**THE CITY OF KEY WEST**

**ADDENDUM NO. 2 – RE-BID REST BEACH STABILIZATION  
ITB 18-011**

RE: **1300 Atlantic Boulevard (C.B. Harvey Rest Beach Park)**  
**(permit application # T17-8522)**

Sheet Reference:  
**C-104**  
Sheet 6 of 23

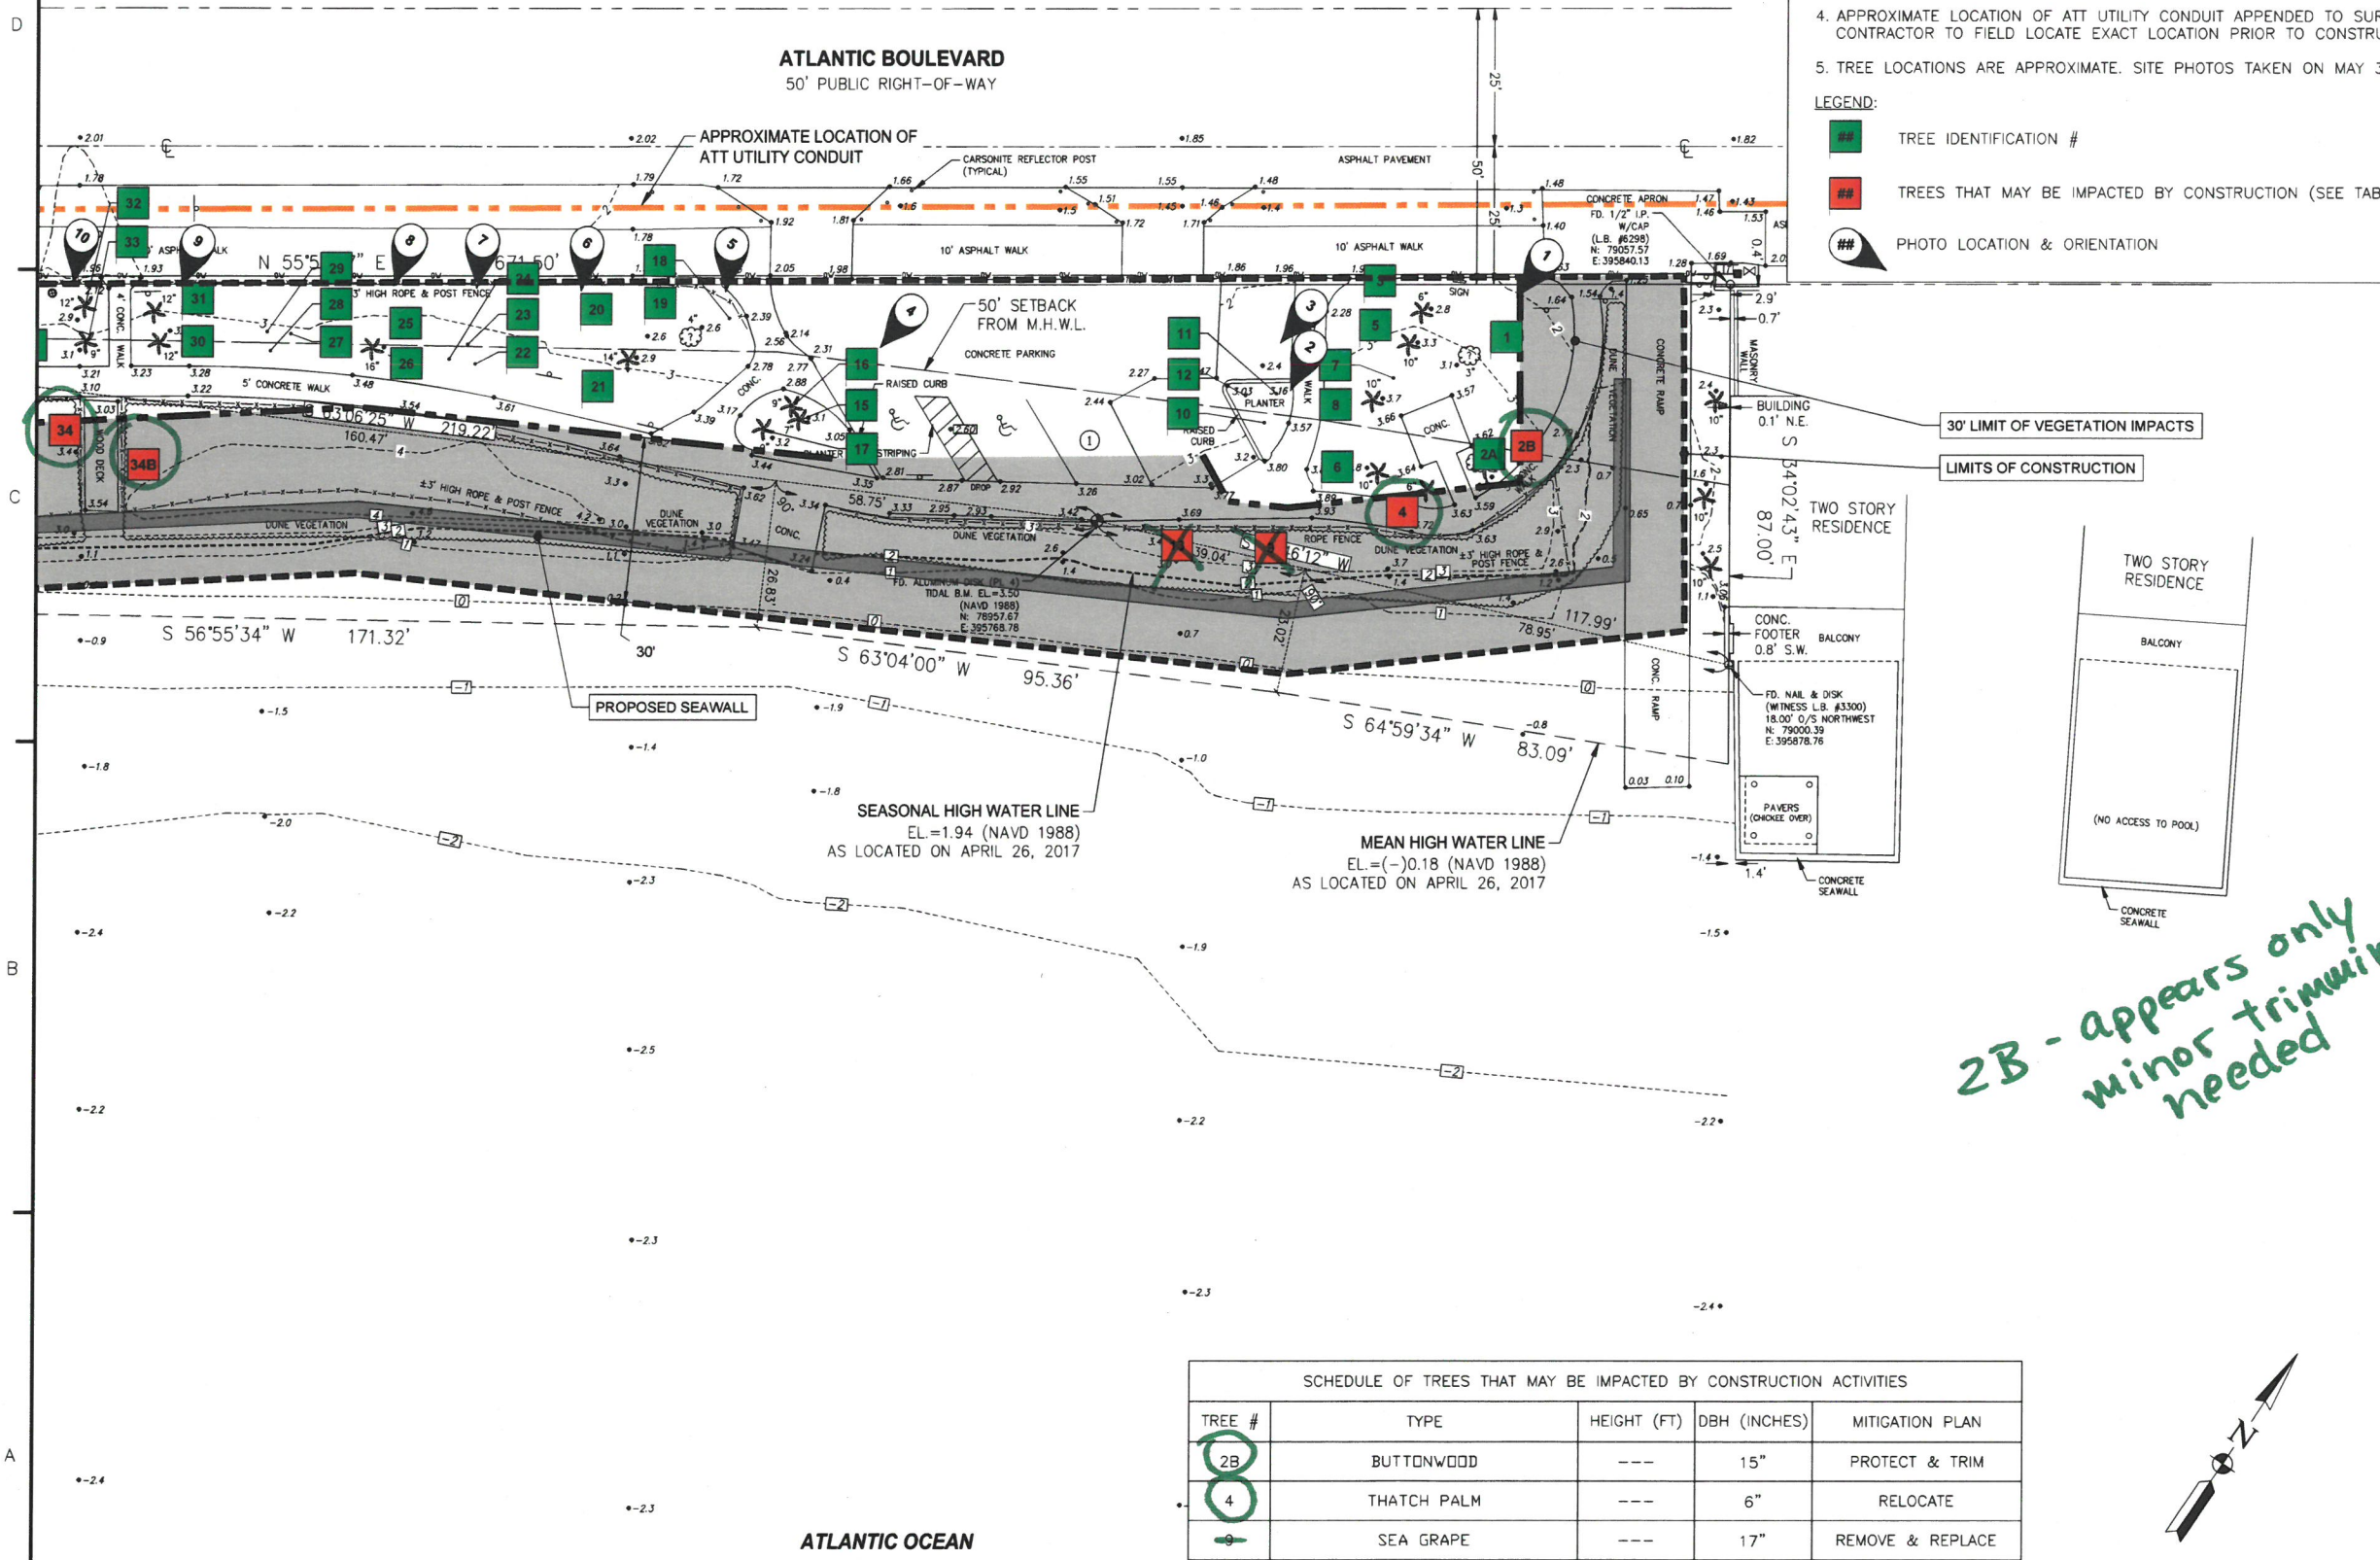
Trees already reviewed by  
Tree Commission circled in green.

Tree 106  
has already  
had some  
trimming.

56 + 82 not  
included in review

DYING

### **FINAL SYNOPSIS: Approved Actions.**

**Trim Only:** Trees 2B and 106 (both trees have had some trimming already done).

**Tree Removal:** Trees 48, 48A, 66, 67, and 68. Requires a total of 30.9 caliper inches of approved tree replacement plus 1-8ft tall tree, minimum 1" diameter.

**Palm Removal:** Tree 70. Required replacement of 1-4ft tall palm tree from approved list.

**Palm Transplants:** Trees 4, 34, 34B, 58, 61, 62A-B, 63, and 86.

Sheet Reference:  
**C-105**  
Sheet 7 of 23

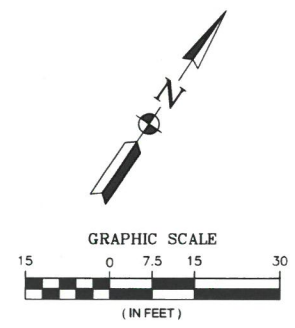
2B - appears only minor trimming needed

Trees already reviewed by Tree Commission circled in green.
